SPI Programming Failure Modes in Specific Use Scenarios with Platform Manager 2, MachXO2, MachXO3, and MachXO4 Products and Work-Around Solutions

Lattice is issuing this Product Bulletin to inform that two potential failure modes are possible when programming external SPI memories via the JTAG-to-MSPI bridge feature with Platform Manager 2, MachXO2, MachXO3, and MachXO4 devices. The failure modes are limited use cases and only a few customers will be impacted. However, for those customers who are using one of these devices in the modes described below, there is a risk of programming and/or verification failure of the external SPI memory.

Figure 1. Issue #1: Race Condition between CSn and MCLK

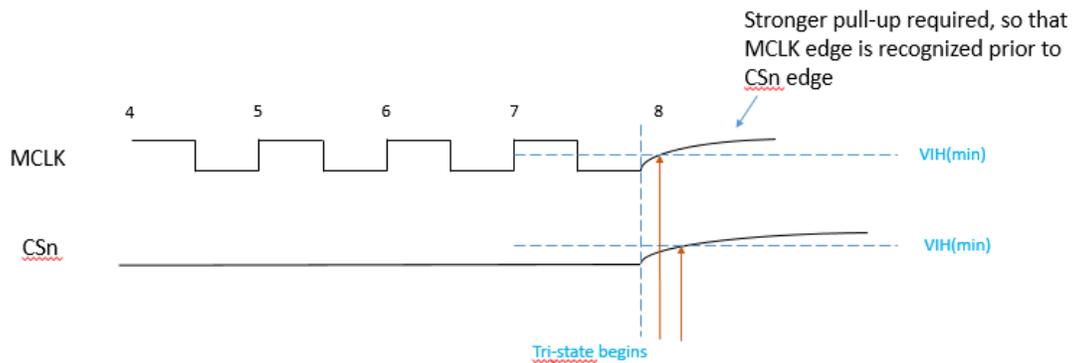
Issue #1: Race condition between CS and MCLK at the end of SPI transaction

This race condition occurs when the JTAG-to-MSPI bridge is used to erase/program/verify the external SPI device. The JTAG command to release control of the SPI embedded function block (EFB) will disable both CS_n and MCLK outputs at the same time. If CS_n wins the race, the SPI device does not see the final MCLK edge. In this situation, the SPI device ignores the final data or command and a programming error occurs. By using different strength pull-ups resistors, MCLK can be forced to rise before CS_n (as shown in Figure 1), to prevent programming errors. Lattice has historically recommended that MCLK use an external 1k pull-up resistor (FPGA-TN-02154 MachXO2 Hardware Checklist and FPGA-TN-02155 MachXO2 Programming and Configuration User Guide) and CS_n relies on the weak pull-up of the I/O or an external 10 k pull-up resistor that is recommended in FPGA-TN-02078 Dual Boot and Background Programming PM2. Therefore, if the existing recommendations are followed, this issue should not be encountered for most customers. It is possible that resistor values must be adjusted depending upon design dependent routing and trace loads in order to ensure proper edge relationships.

Figure 3. Recommended SPI Interface Circuit with Buffer Delay.

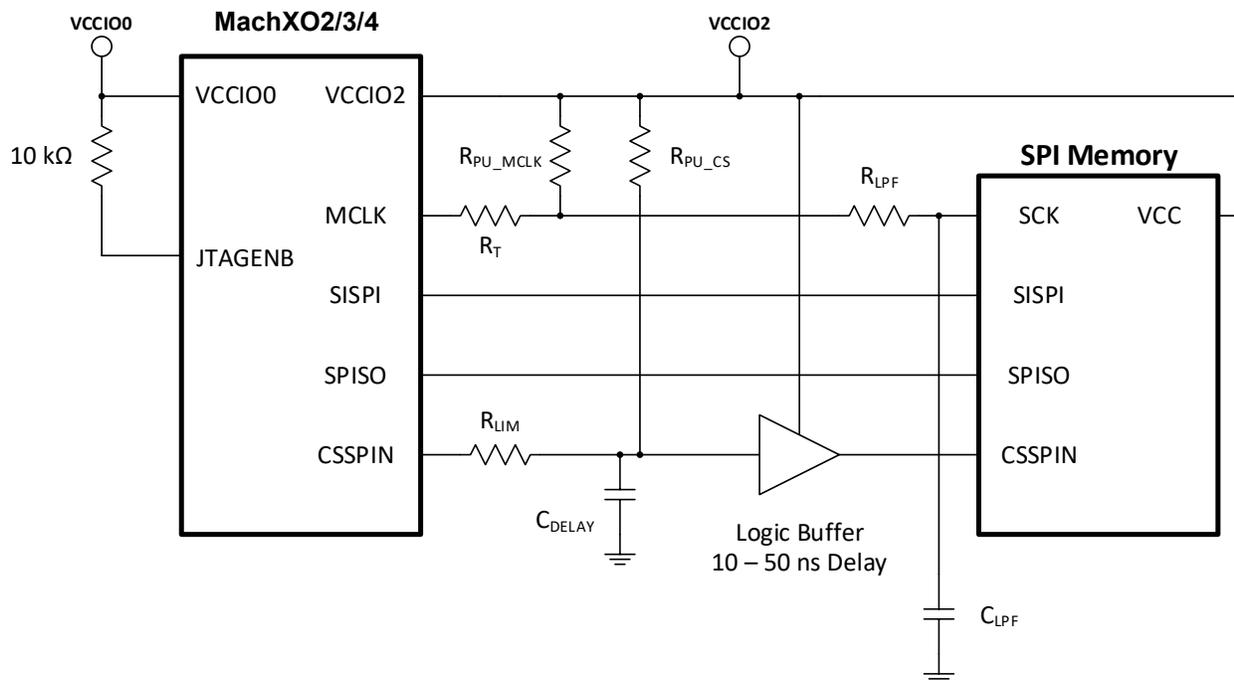
This section provides the hardware guidelines that mitigate both of the race conditions described above: the race condition between CSn and MCLK and the race condition between the OE of MCLK and the rising transition. These guidelines provide a generic architecture that supports tuning between the two race conditions and the characteristics of the PCB and various SPI devices. The guidelines below are most suitable for new designs and design re-spins.

This architecture calls for a low-pass filter at the input of the SPI clock pin. The low-pass filter attenuates the ringing issue but adds a negative delay to the race condition between CSn and MCLK. An external delay circuit is used to restore the correct timing between CSn and MCLK and compensates for the low-pass filter delay.

Figure 3 shows the external delay circuit using a logic buffer with an R-C delay on the input. This circuit provides a wide range of RC delays by adjusting the values of RPU_CS and CDELAY. Table 1 lists some typical values and corresponding delays for prototyping. Production values will depend on board layout and component selection (including the MCLK low-pass filter values). A current limiting resistor (RLIM) is needed to isolate the capacitive loading of CDELAY from the CSSPIN driver and a value of 200 Ω will work for the supported LVCMOS I/O standards (3.3 V to 1.2 V).

The final design consideration for the buffer delay circuit is the voltage divider of R_{PU_CS} and R_{LIM}. When CSSPIN goes low the divided voltage value must meet the input-low specification for the buffer (or other logic element). Given the value of 200 Ω for R_{LIM}, R_{PU_CS} should be 1 kΩ or greater for typical LVCMOS standards.

Ultimately, the design depends upon device availability and/or extra resources already in the schematic. One option that will not work is using the FPGA as a buffer because, the buffer is not in the fabric until after the device is configured by the pattern in the SPI device.

R_{PU_CS} (k Ω)	C_{DELAY} (pF)	Approximate Delay (ns)
1	10	10
2	10	20
3.3	15	50

Figure 4. Recommended SPI MCLK Interface Circuit.

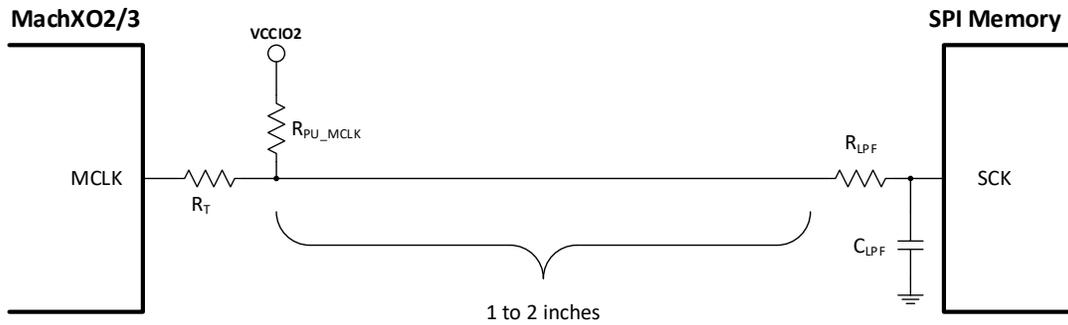
Figure 4 zooms in on the recommended SPI interface circuit for the clock signal (MCLK). On the left, the transmission line matching resistor (RT) is located as close to the MachXO2/3 as possible. The value of RT combined with the output impedance of the MachXO2/3 should match the PCB trace impedance. Typical values for RT range from 22 Ω to 33 Ω for a PCB trace impedance of 50 Ω.

The pull-up resistor (R_{PU_MCLK}) will pull the clock signal high when MCLK's output is disabled or tri-stated. In the past, a recommended value of 1 k was used to solve the CS_n to MCLK race condition. However, an external circuit is now recommended to provide the required delay and the strong pull-up value makes the ringing issue more severe. A value between 4.7 k and 10 k should be used for R_{PU_MCLK}.

The transmission line for MCLK should be kept as short as possible (and length matched with the data SPI signals). On the right side of Figure 4 the R-C low-pass filter (RLPF & CLPF) is shown. This filter should be located as physically close to the SPI clock input as possible to maintain signal integrity of the clock signal. Table 2 lists typical values for prototyping; production values will depend on PCB layout and final component selection.

R_{LPF} (Ω)	C_{LPF} (pF)	Low Pass Corner (f_3 MHz)	Delay (ns)
200	16	50	3.2
100	16	100	1.6
50	32	100	1.6
33	48	100	1.6
